June 16, 2022: Responses to PSC's unresolved comments dated May 4, 2022. For reference, PSC's unresolved comments are provided in red. Further updated on June 29, 2022.

**Re: 518 and 540 South Avenue Comprehensive Permit
Response to Comments**

On behalf of Hanover R.S. Limited Partnership, Tetra Tech (Tt) has prepared the following responses to Civil Engineer comments raised during the May 10, 2022 public hearing by the Board's Peer Review Consultant, PSC and Chessia Consulting Services.

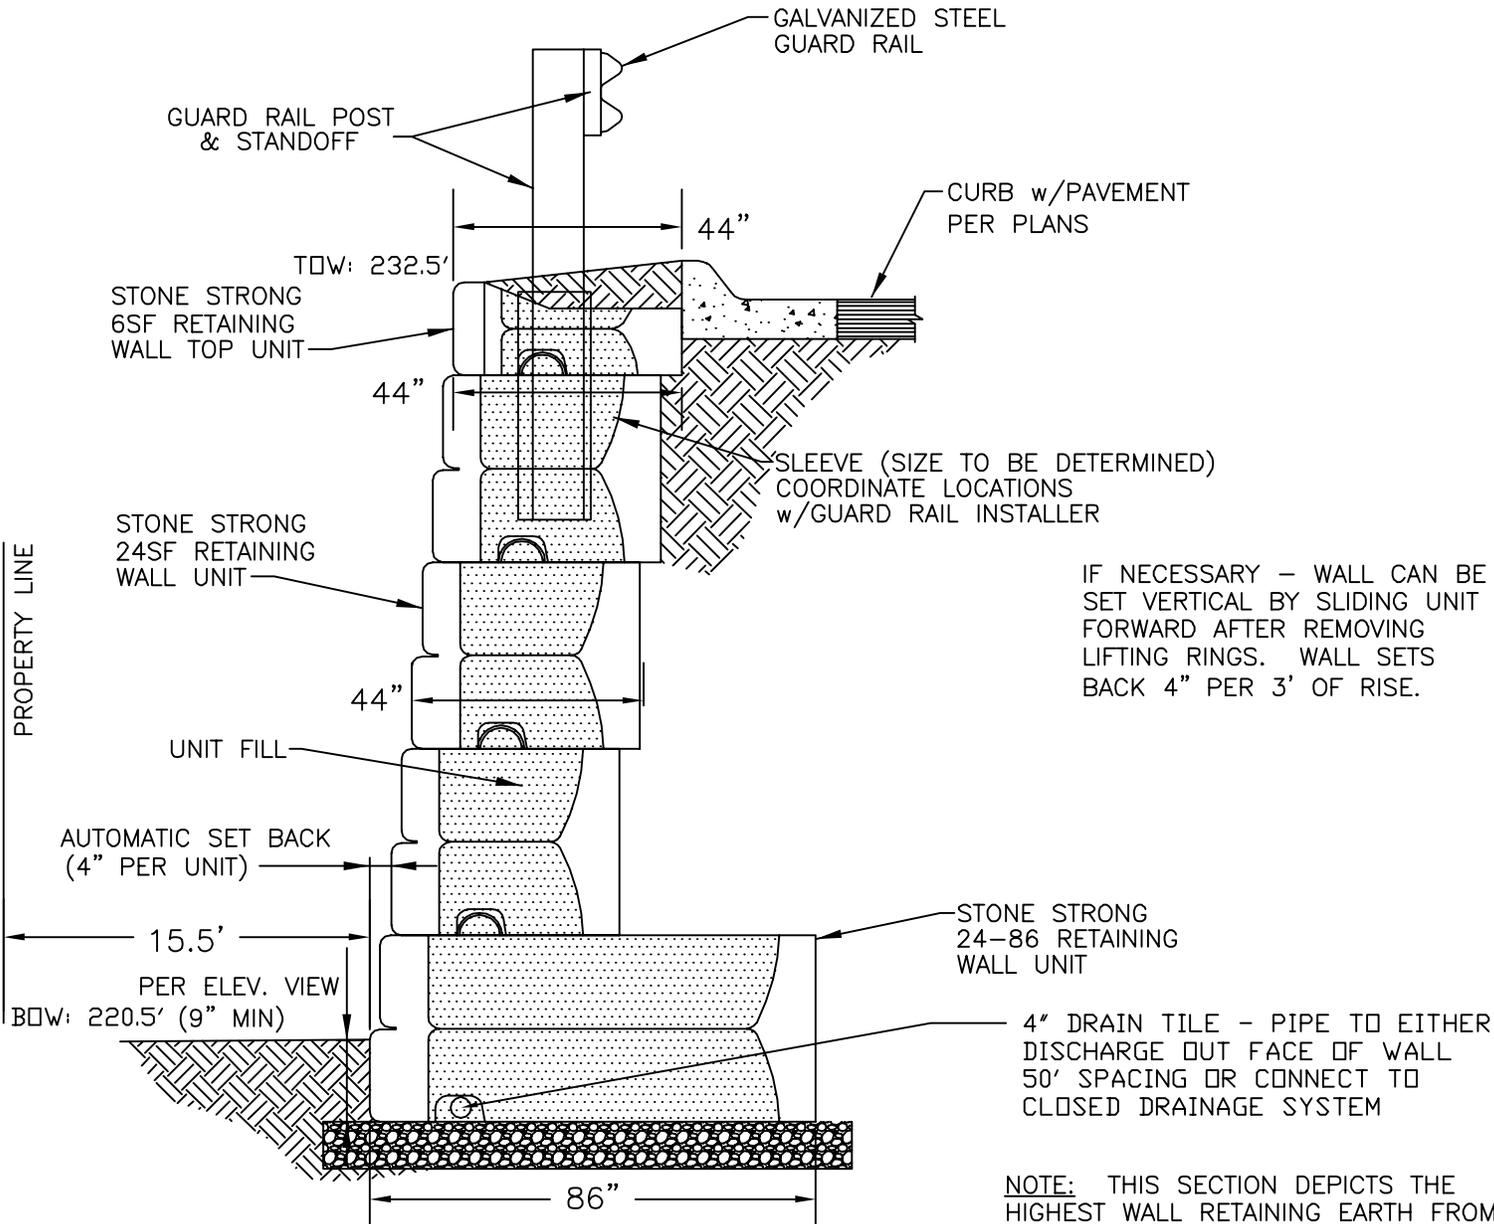
PSC 66	The proposed retaining walls need to be designed by a Massachusetts registered Structural Engineer. Calculations for factor of safety against overturning, sliding and bearing capacity are required for any section over 4-feet in height, and the proximity of wetlands and conditions of high groundwater and groundwater mounding should be factored into the design. If the structural plans are provided by a wall manufacturer, then the Board should require that the plans be based on site specific geotechnical information and they should not accept plans that are qualified by requiring further determination of geotechnical conditions after issuance of the signed and sealed structural drawings.	Tetra Tech	Tetra Tech has been coordinating with MBO Precast, the local representative for Stone Strong Retaining Walls. MBO Precast has reviewed the site retaining walls with their desingner, Civil Connection. Civil Connection has developed three retaining wall sections to demonstrate wall constructability. A section has been cut near the northeast corner of the building, in the largest fill area. A section has also been cut at the southwest corner of the building, in the largest cut. Finally, a section has been cut adjacent to the porous pavement. As shown in the sections, all walls can be constructed as gravity walls, without the need for reinforcing. <small>The revised plans do not demonstrate feasibility of wall construction, e.g., feasible setback from the 25-ft no touch zone on east side, from sections of porous pavement, and from property lines. Also, wall Sections SK1, SK2 and SK3 included with the response matrix are not shown on details Sheet C-14. Details should dimension proposed wall and block heights and depths (face to back) and all dimensions from the aforementioned features. Also, provide a detail of fence installation at the walls.</small> Please refer to Tetra Tech's May 18, 2022 discussion on "Retaining Walls".

<p>The plans include extensive retaining walls essentially surrounding the site. The few details provided are generic and based on a review the retaining walls would interfere with other proposed features depending on the location and height of the walls. The Applicant expressed at the public hearing on December 14, 2021 that they have extensive experience with construction of retaining walls. The design engineer also indicated that he is familiar with the design parameters of these walls. The Board should require the Applicant to supply actual cross sections at specific areas where parameters such as height, proximity to porous pavement, fill or cut section, etc. around the entire site. There were inconsistencies in the presentation by the Applicant relative to the types of walls proposed in various locations versus the labels on the plans. It is unclear where an impervious barrier is proposed and it is my understanding that this was not a consideration in the groundwater mounding analysis although it was represented at the hearing that there would be a barrier along the wall near the wastewater effluent leaching area. The Board should require that this aspect be completely designed and detailed with the actual dimensions of the proposed walls determined to understand if they are even feasible as proposed. Additional details are also required to model the effect of the retaining walls on groundwater mounding.</p>	Tetra Tech	<p>These are details that will be developed as part of the retaining wall design and will be submitted with the Building Permit for the retaining walls. However for reference, we have attached typical details from Stone Strong that fence and guard rail installation with the retaining walls. We have also included a detail for a 42 inch base block that can be used in gravity retaining walls up to 7.5 feet in height. These blocks would be used along the west property line. Mounding effects associated with the retaining walls are addressed in responses to MMA's and Mr. Davis's comments.</p>

Retaining Walls: Retaining walls near the perimeter of the property are fundamental to the project design and will not be eliminated, reduced in height, or relocated. Adequate design detail, sufficient to prove the feasibility of the wall construction, has been provided during the ZBA process, including updated key retaining wall sections with dimensions of wall blocks, offsets to property lines and pavement. A fully engineered design will follow during the building permit process. Most of the walls will not be visible from neighboring properties. The applicant is willing to provide landscape screening on abutting properties for those abutters concerned about the visual aesthetics of the wall. However, the regional need for affordable housing outweighs any local concern over the visibility of retaining walls. Finally, the groundwater mounds developed under wastewater and stormwater disposal areas do not intrude into the wall footings, so they do not impact the structural stability of the walls.

NOTE: THIS SECTION DEPICTS THE HIGHEST WALL RETAINING EARTH FROM OFFSITE. THE MINIMUM DIMENSION REQUIRED TO INSTALL THE WALL BETWEEN POROUS PAVEMENT AND THE PROPERTY LINE IS 5 FEET. AT THE CLOSEST POINT, THE POROUS PAVEMENT IS SET 6.5 FEET FROM THE PROPERTY LINE.

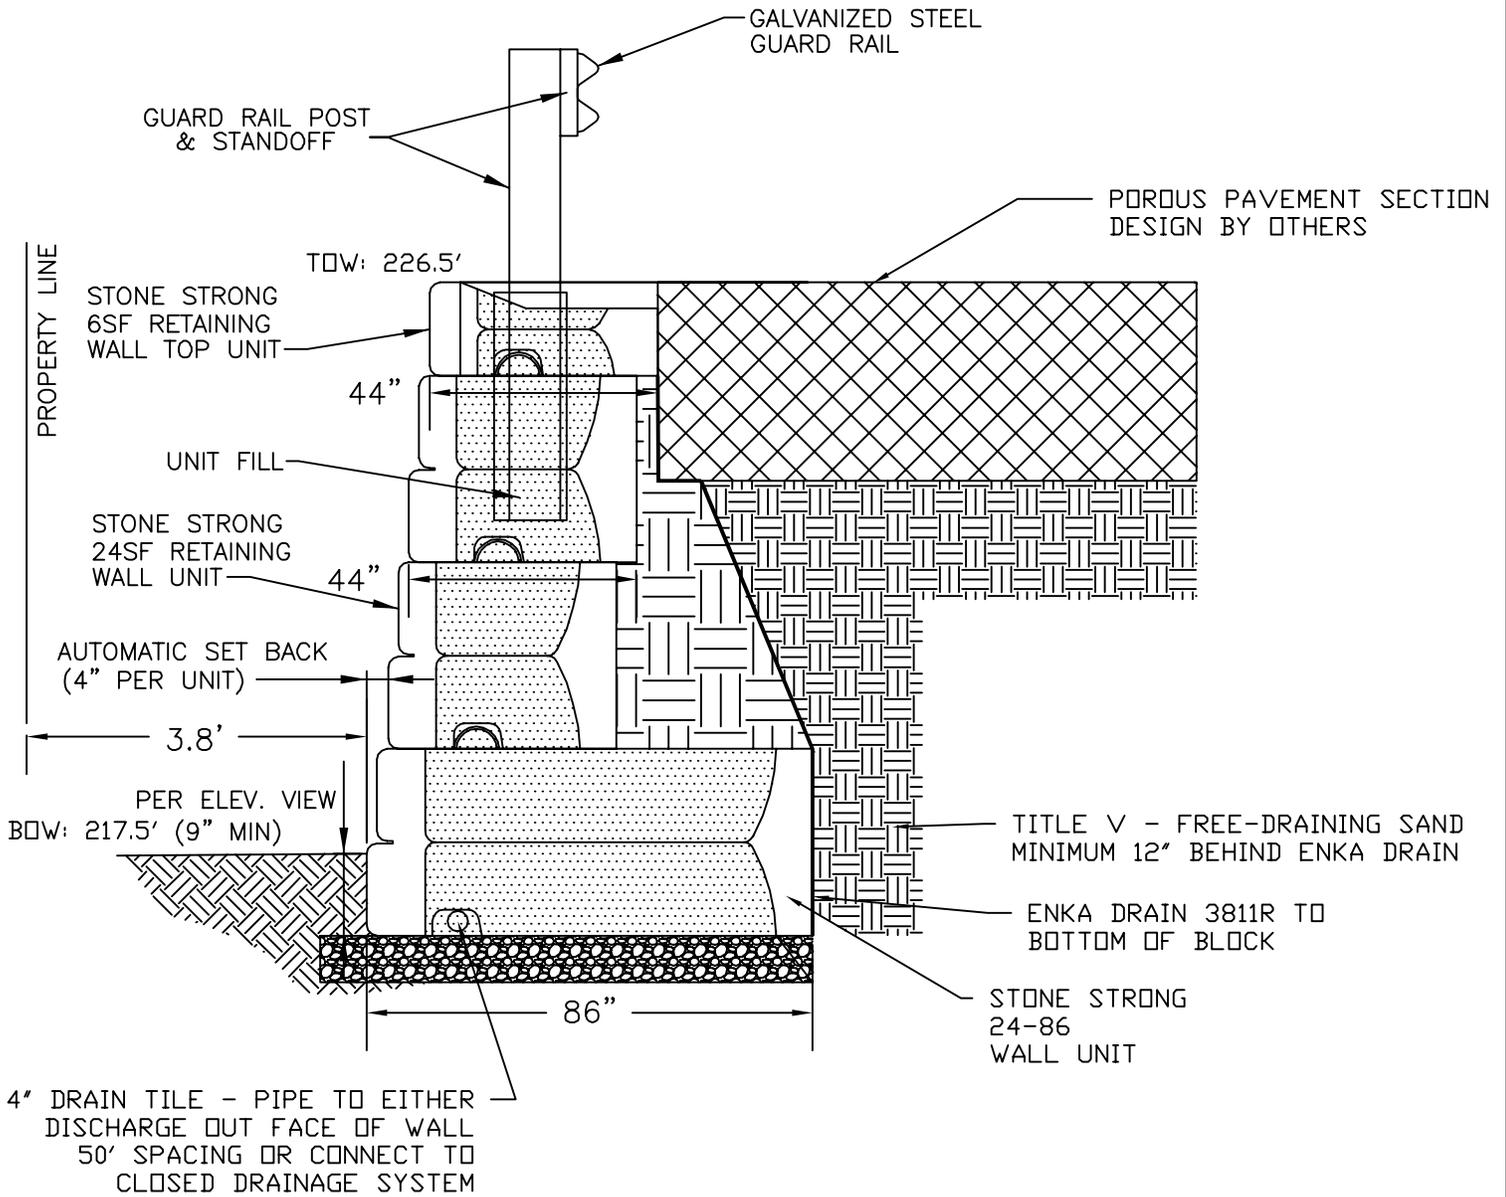
PSC 67	Provide a detail showing guardrail installation for retaining walls capable of resisting horizontal impact loads.	Tetra Tech	These are details that will be developed as part of the retaining wall design and will be submitted with the Building Permit for the retaining walls. However, MBO Precast, the local Stone Strong Retaining Wall Representative, has provided 3 key retaining wall sections, developed by their design Engineer, Civil Connection. Two of the retaining wall sections include guardrails. The guard rail post will be sleeved through the hollow cores of the retain wall blocks. Please refer to SK1-3.
PSC 68	The Zoning Board of Appeals will have to determine the acceptability of these retaining walls from an aesthetic and zoning aspect, especially considering the walls as structures are not compliant with yard setbacks.	Tetra Tech	Relief from local zoning setbacks has been requested.

NOTE: THIS SECTION DEPICTS THE HIGHEST WALL RETAINING EARTH FROM ONSITE. THE MINIMUM DIMENSION REQUIRED BETWEEN THE FACE OF WALL AND THE PROPERTY LINE IS 1’.
